## Product Change Notice (PCN)

**Subject:** Addition of back-end production for general-purpose linear IC products (SOP package products)

**Publication Date:** 6/30/2023

### SOP-8 :

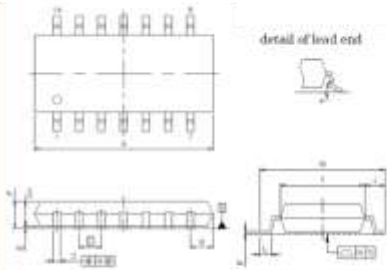
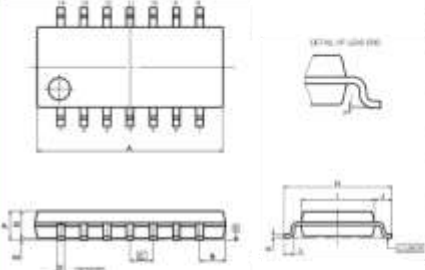
There are some dimensional differences in the outline drawing, but the recommended foot pattern remains the same.

Current products		UTL products																																																																	
(UNIT:mm)		(UNIT:mm)																																																																	
	<table border="1"> <thead> <tr> <th>ITEM</th> <th>MILLIMETERS</th> </tr> </thead> <tbody> <tr><td>A</td><td>5.2 +0.17 -0.20</td></tr> <tr><td>B</td><td>0.78 MAX</td></tr> <tr><td>C</td><td>1.27 (T.P)</td></tr> <tr><td>D</td><td>0.42 +0.08 -0.07</td></tr> <tr><td>E</td><td>0.1 ±0.1</td></tr> <tr><td>F</td><td>1.59 ±0.21</td></tr> <tr><td>G</td><td>1.49</td></tr> <tr><td>H</td><td>6.5 ±0.3</td></tr> <tr><td>I</td><td>4.4 ±0.15</td></tr> <tr><td>J</td><td>1.1 ±0.2</td></tr> <tr><td>K</td><td>0.17 +0.08 -0.07</td></tr> <tr><td>L</td><td>0.6 ±0.2</td></tr> <tr><td>M</td><td>0.12</td></tr> <tr><td>N</td><td>0.10</td></tr> <tr><td>P</td><td>3° +7° -3°</td></tr> </tbody> </table>	ITEM	MILLIMETERS	A	5.2 +0.17 -0.20	B	0.78 MAX	C	1.27 (T.P)	D	0.42 +0.08 -0.07	E	0.1 ±0.1	F	1.59 ±0.21	G	1.49	H	6.5 ±0.3	I	4.4 ±0.15	J	1.1 ±0.2	K	0.17 +0.08 -0.07	L	0.6 ±0.2	M	0.12	N	0.10	P	3° +7° -3°		<table border="1"> <thead> <tr> <th>ITEM</th> <th>DIMENSIONS</th> </tr> </thead> <tbody> <tr><td>A</td><td>5.2±0.17</td></tr> <tr><td>B</td><td>0.78MAX</td></tr> <tr><td>C</td><td>1.27(T.P)</td></tr> <tr><td>D</td><td>0.40±0.05</td></tr> <tr><td>E</td><td>0.1±0.1</td></tr> <tr><td>F</td><td>1.59±0.21</td></tr> <tr><td>G</td><td>1.49</td></tr> <tr><td>H</td><td>6.5±0.3</td></tr> <tr><td>I</td><td>4.4±0.1</td></tr> <tr><td>J</td><td>1.05±0.15</td></tr> <tr><td>K</td><td>0.2±0.07</td></tr> <tr><td>L</td><td>0.6±0.20</td></tr> <tr><td>M</td><td>0.1MAX</td></tr> <tr><td>N</td><td>0.1MAX</td></tr> <tr><td>P</td><td>4°±4°</td></tr> </tbody> </table>	ITEM	DIMENSIONS	A	5.2±0.17	B	0.78MAX	C	1.27(T.P)	D	0.40±0.05	E	0.1±0.1	F	1.59±0.21	G	1.49	H	6.5±0.3	I	4.4±0.1	J	1.05±0.15	K	0.2±0.07	L	0.6±0.20	M	0.1MAX	N	0.1MAX	P	4°±4°

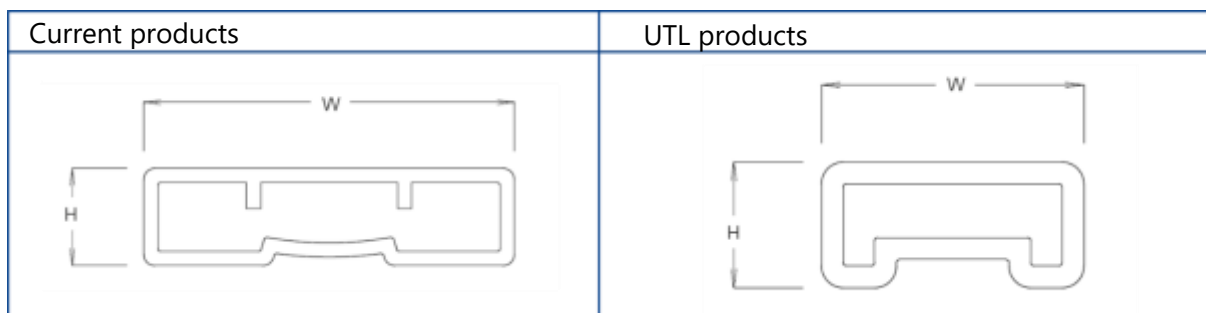
The size of the tape packaging box is different as follows.

Current products (L×W×H)	UTL products (L×W×H)
368×347×54 (mm)	355×370×55 (mm)

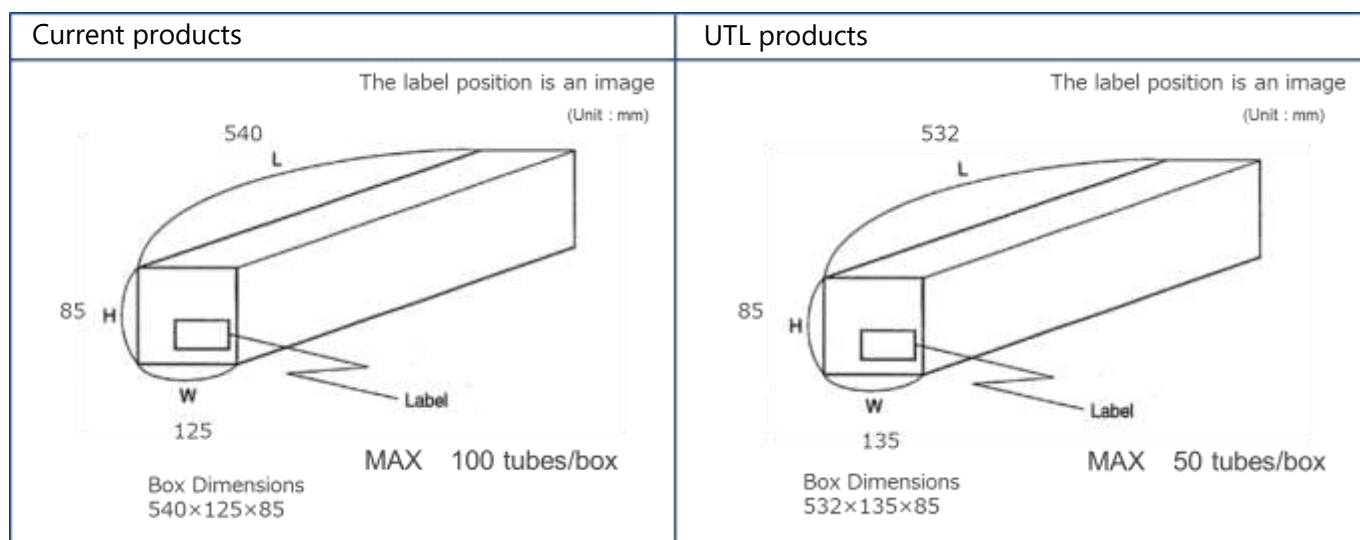
The size of the tube is different as follows.

PKG	Current products (L×W×H), Quantity	UTL products (L×W×H), Quantity
SOP-8	530×13×3.4 (mm), Max100pcs	507~509×8.4×4.0 (mm) , Max90pcs
SOP-14	530×13×3.4 (mm), Max50pcs	507~509×8.4×4.0 (mm) , Max45pcs
